INSTRUCTION TO SERVICE

ITS: 58508

SECTION:	219 ENGINE & TRANSMISSION.
WRITTEN BY:	Michael Rooney
SUBJECT:	Retrofit new PEM Motor mounting & Fuel Cell mounting hardware.

Figure 2: PEM Motor Mounts.

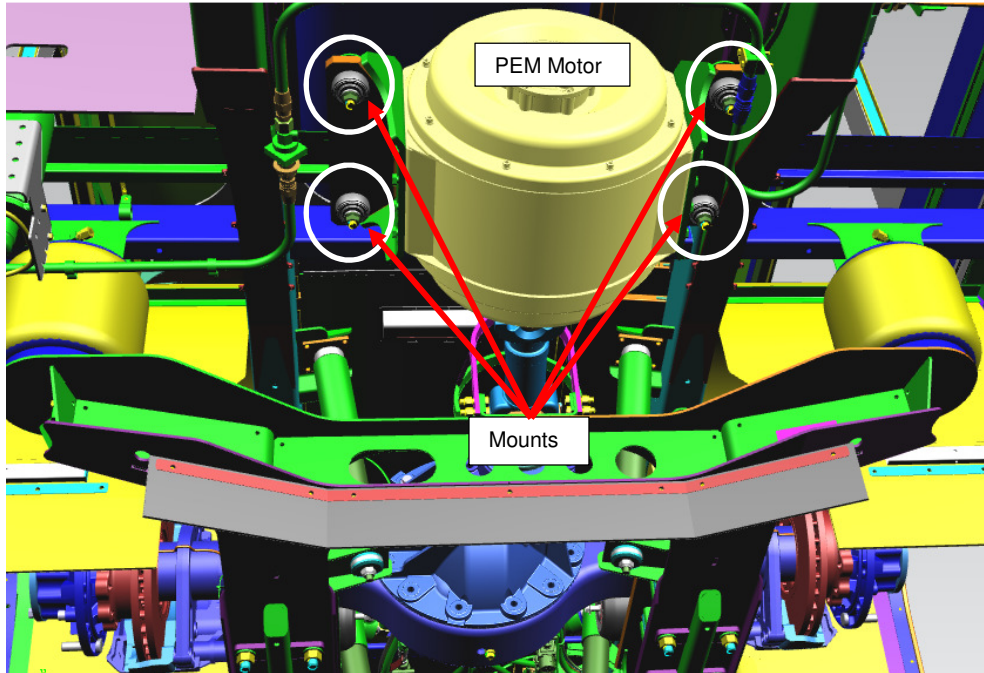
5. One at a time, replace the four PEM Motor mounting bolts and nuts using the following procedure at each mounting location.
 - a. Remove the 5/8" nut and washer on the underside of the mount. Set the washer aside for reinstallation later.
 - b. Remove the 5/8" x 4.5" bolt from the top. Do not lose the 66 MM washer on top of the rubber isolator under the bolt head.
 - c. Insert a new 5/8" x 4.5" bolt NF P/N 10B10072 from the top.
 - d. Reinstall the washer set aside earlier then install a new 5/8" nut NF P/N 40N10000. Torque the nut to 160 ± 10 FT-LBS (DRY).

Figure 4: Front Fuel Cell Mount (Part of Bracket Removed for Clarity).

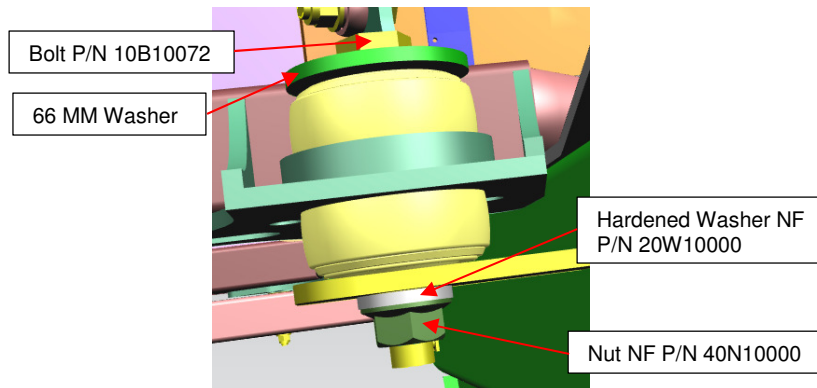
7. Remove and replace the front mount hardware one at a time using the following procedure on each mount.
 - a. Remove the 5/8" nut and washer on the underside of the mount. Discard both.
 - b. Remove the 5/8" x 4.25" bolt from the top. Do not lose the 66 MM washer on top of the rubber isolator under the bolt head.
 - c. Insert a new 5/8" x 4.50" Bolt NF P/N 10B10072 from the top.

- d. Install a new hardened Washer NF P/N 20W10000 and a new 5/8" Nut NF P/N 40N10000. Torque the nut to 106 FT-LBS (DRY).

Figure 5: Rear Fuel Cell Mounts (Chassis Cross Member Removed for Clarity).

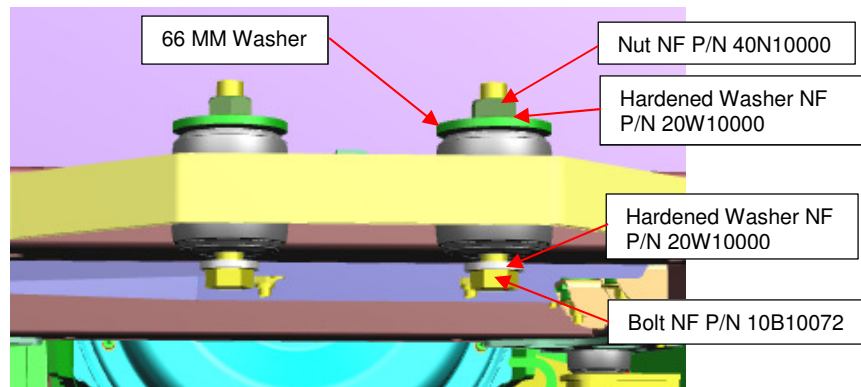
8. Remove and replace the rear mount hardware one at a time using the following procedure on each mount.
 - a. Remove the 5/8" nut on the top of the mount. Remove the 66 MM washer and set it aside for reuse.
 - b. Remove the 5/8" x 4.25" bolt from the bottom through the opening in the cross member. Discard the bolt and the washer under the bolt head.
 - c. Install a new Hardened Washer NF P/N 20W10000 on a new Bolt NF P/N 10B10072 then insert the bolt through the cross member and isolators from the bottom.
 - d. Reinstall the 66 MM washer removed earlier and then install a new Hardened Washer NF P/N 20W10000 and new Nut NF P/N 40N10000. Torque the nut to 106 Ft – LBS (DRY).
